Title		
BASE TRANSMITTER		
Size	Number	Revision
C		D
Date:	18-Oct-1999	Sheet of
File:	G:\CHRIS\Xmtrtd.sch	Drawn By: WH

Size	Number	Revision
C	1	D
Date:	18-Oct-1999	Sheet 01
File:	G:\CHRISTC\based.sch	Drawn By:WH

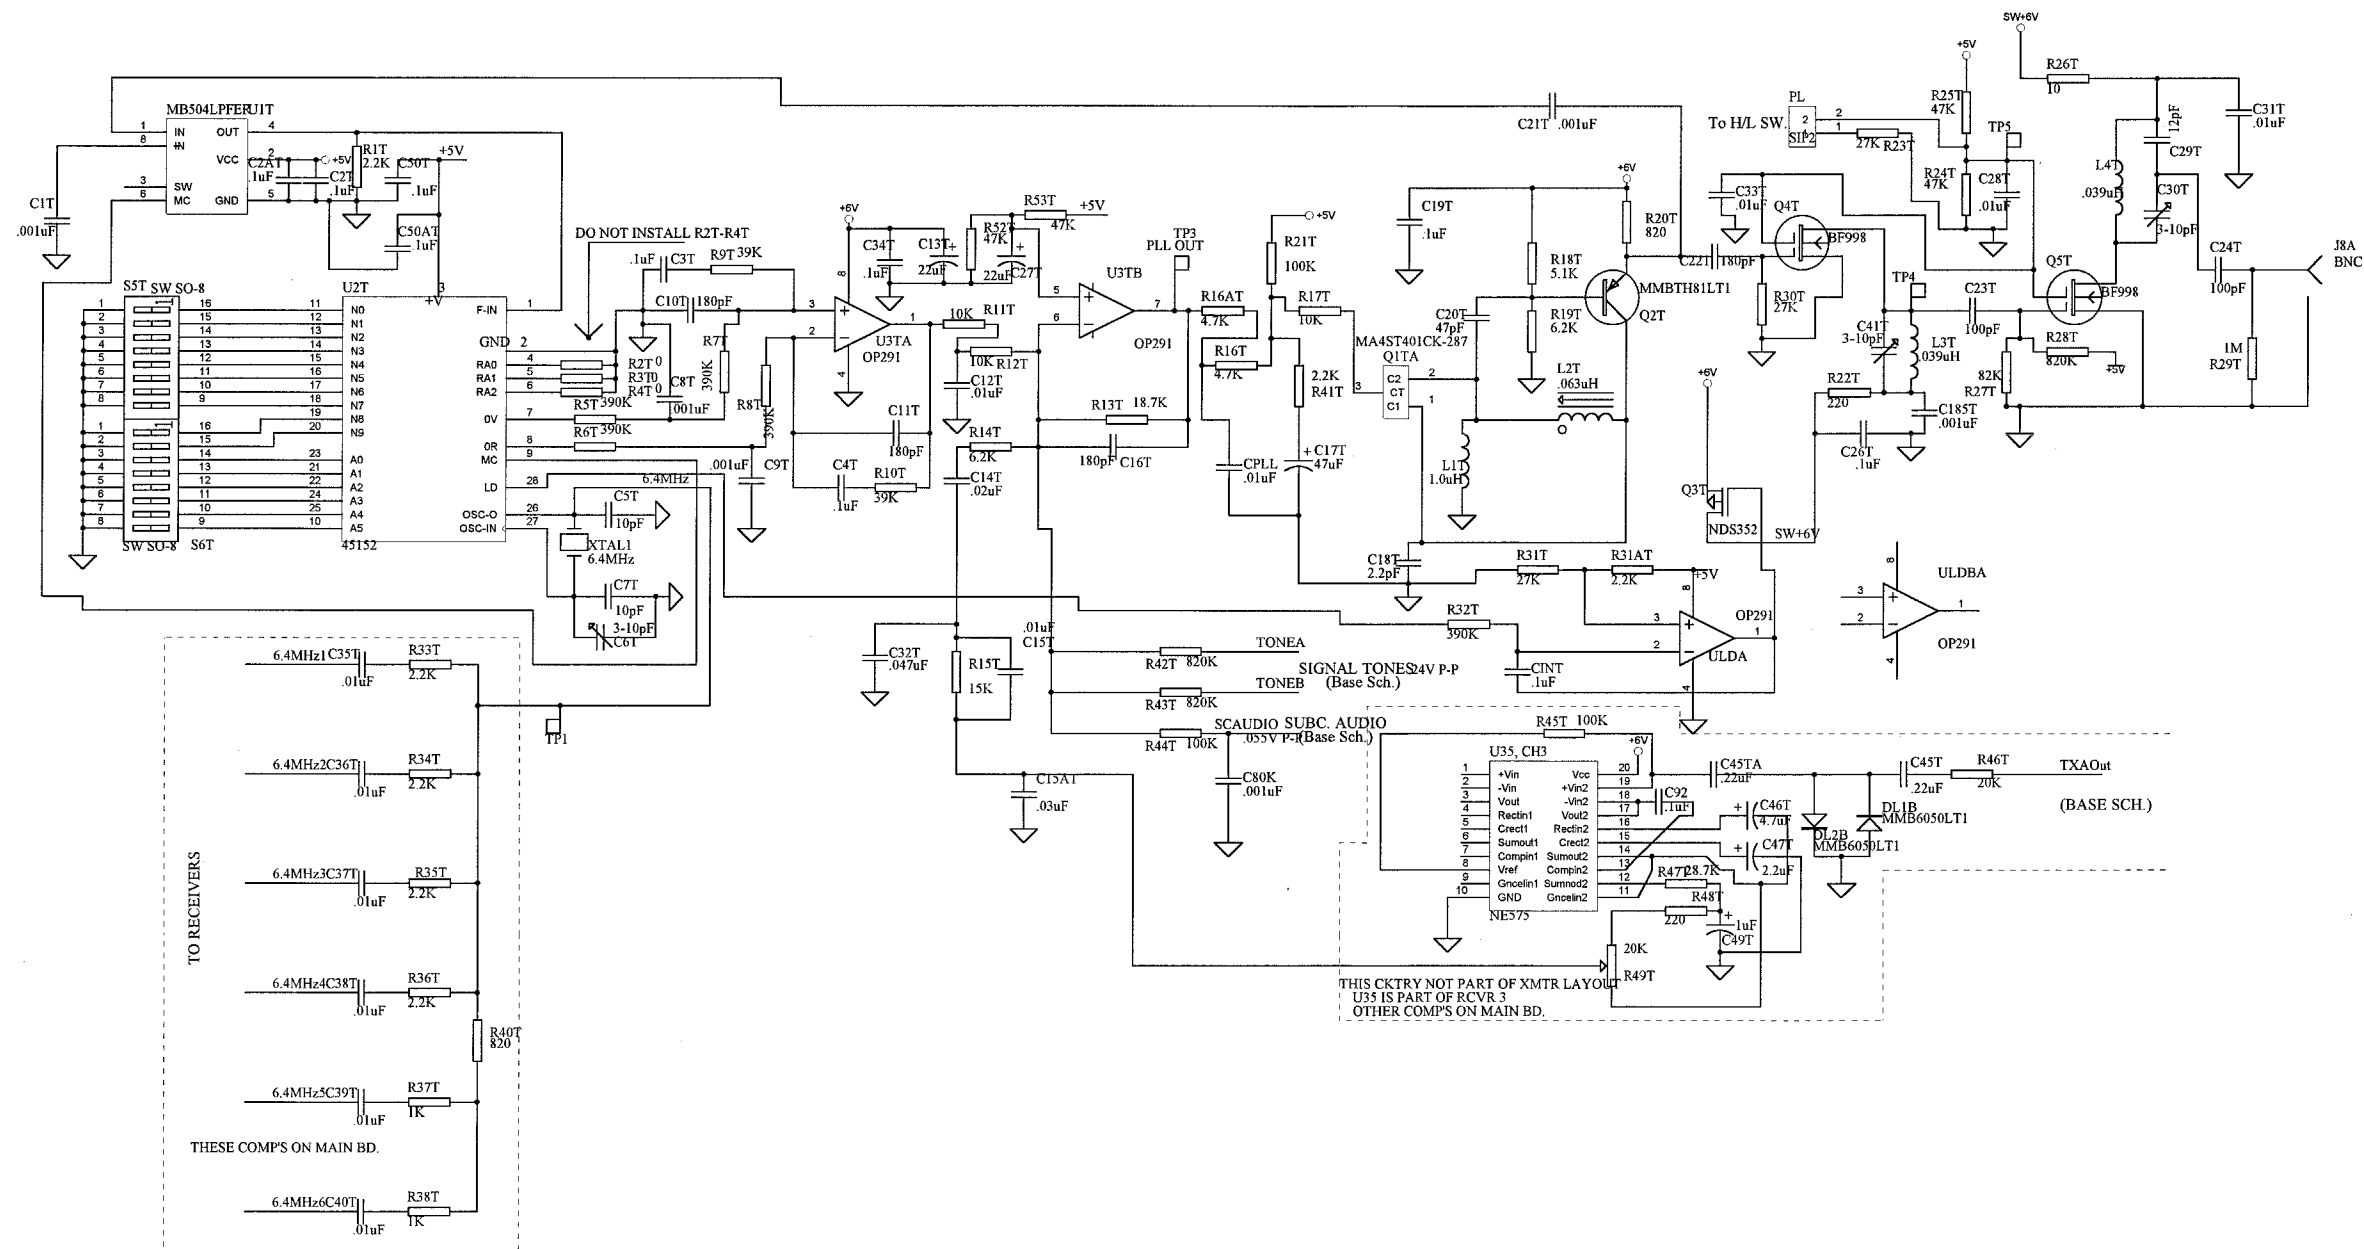
Changes: R33T - R36T to 1K, R40T to 820, R37T & R38T to 820, R22T to 220, R26T to 10, C7T to 12p, C45T to .22
 Add: R7 = 820, C7 = .001, C7 = .22, R7 = 100, C7 = 470p

Note: Check C45T on PCB (make sure pad is not grounded)

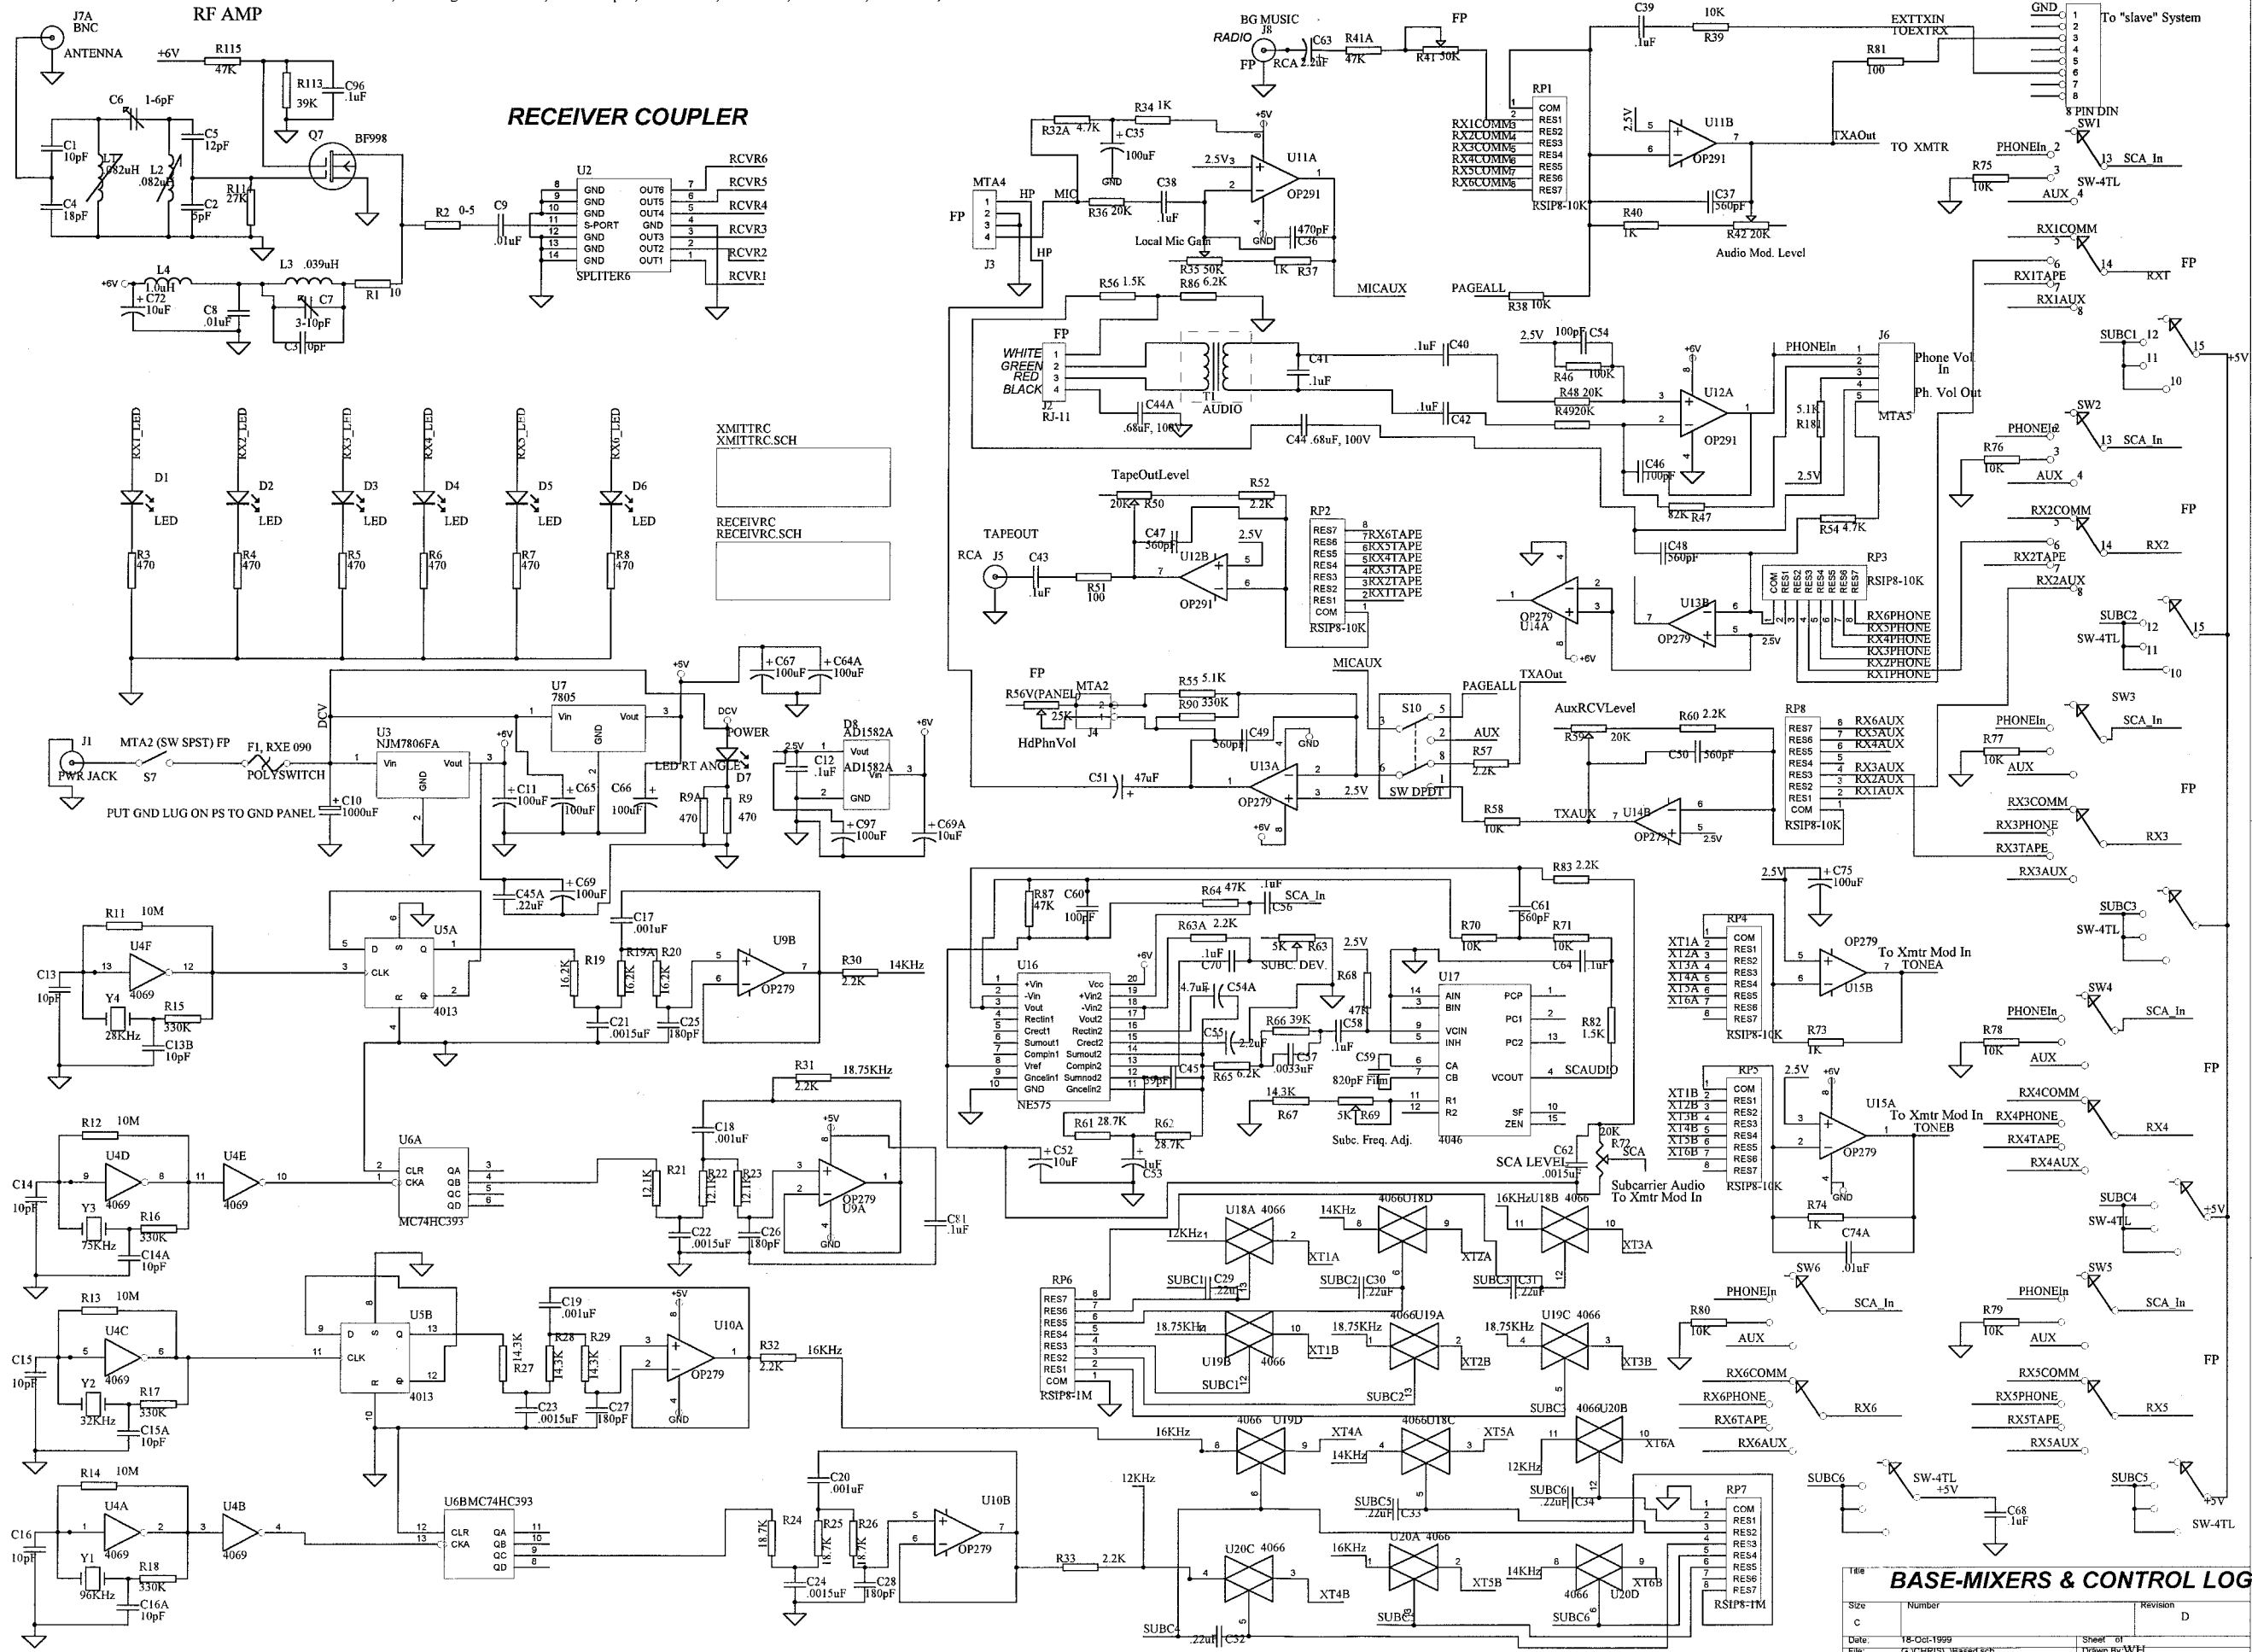
June 1, '99: Change R63A to 2.2K, R63 to 5K pot., R67 to 16.2K, R66 to 47K, C57 to .0033, R2 to 0 to 5, R1 to 10
